**MN Department of Labor and Industry,
Construction Codes and Licensing Division**

2024 Residential Energy Code Technical Advisory Group

**Code Change Proposal Compilation for the
Review of the 2021 IECC-R**

Figure 1: Figure 1: COST COMPARISON BETWEEN PASSIVE HOUSE AND NON-PASSIVE HOUSE PROJECTS [1]

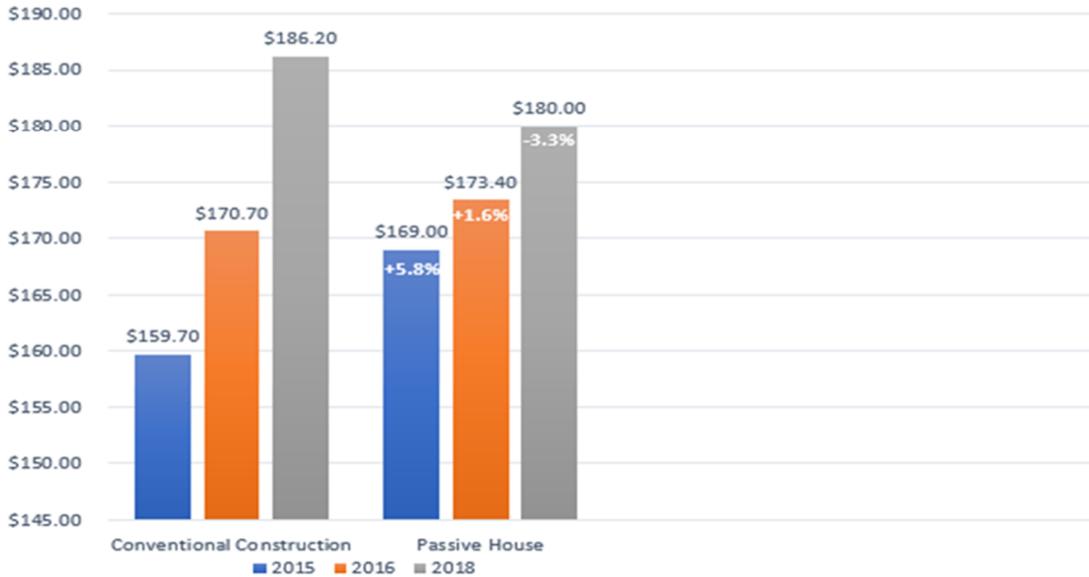
1. **As a result of a well-designed incentive structure, affordable housing in Pennsylvania has seen an increase in projects starting in 2015. Because these projects are funded by the Pennsylvania Housing Finance Authority, costs are tracked very closely. Following is a chart outlining the decrease in cost over a three year period; See Figure 1.**

Figure 3: Boston Energy Benchmarking Data (NESEA BuildBoston Conference 5/7/2021)
Boston Energy Benchmarking Data

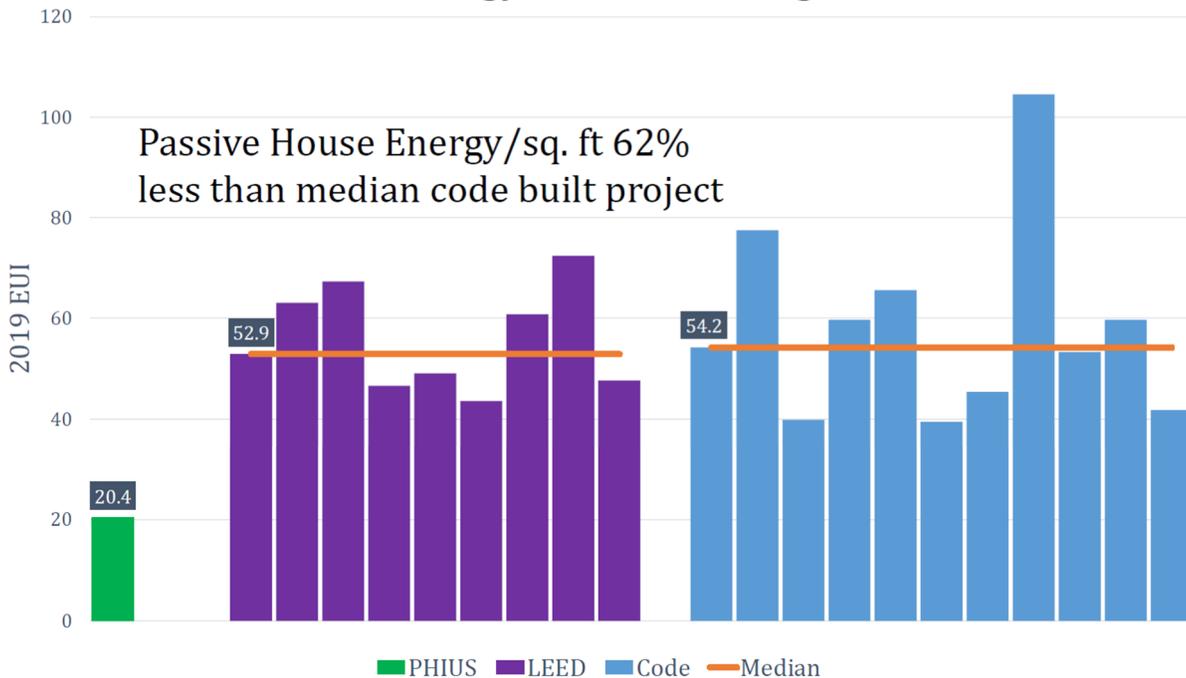
There are several studies that highlight the energy savings that can be expected from buildings receiving the Passive House standard. One such study:

- At the 2022 NESEA BuildBoston conference, the Massachusetts Department of Energy Resources presented the results of an analysis of the energy use of multi-family buildings. DOER found that Plius buildings had an Energy Use Intensity 60% below the code level energy use. Similar data from the Philadelphia benchmarking data analysis shows energy savings of around 50%. (Apigian, Michele et al. At the Finish Line: How Two Affordable passive Projects Crossed the Hardest Hurdles; BuildingEnergy Boston, February 28, 2022)

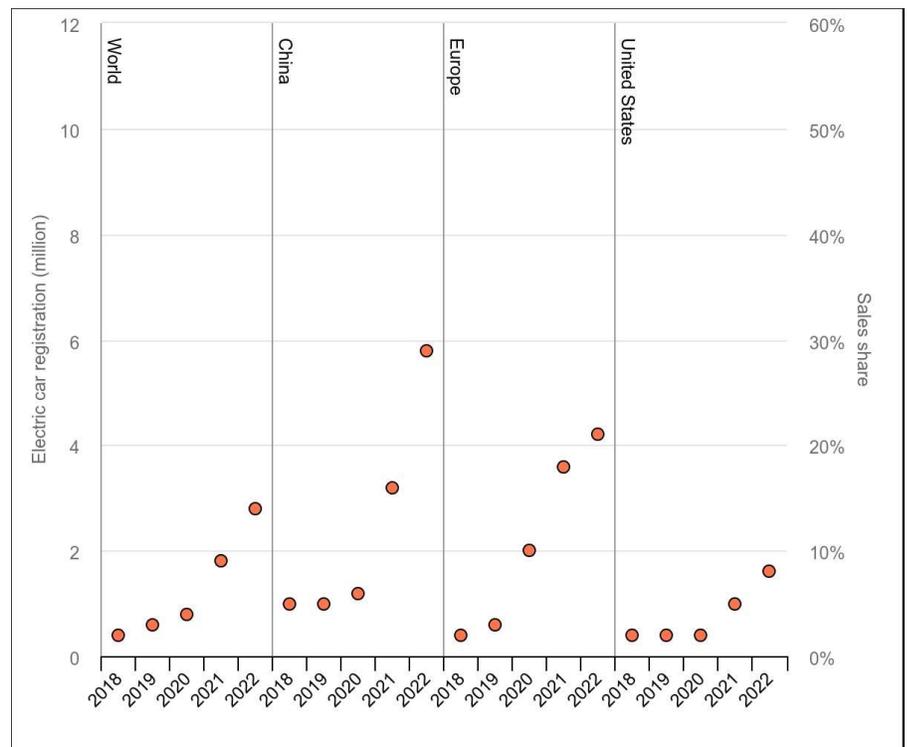
New EV sales in the United States hovered around a quarter million each year from 2016 to 2020, and has since grown to over 1.5 million new vehicles in 2023.²

EVs are on track to pass 10% of new vehicle sales soon in the United States, while globally they were almost 15% of sales in 2022.³
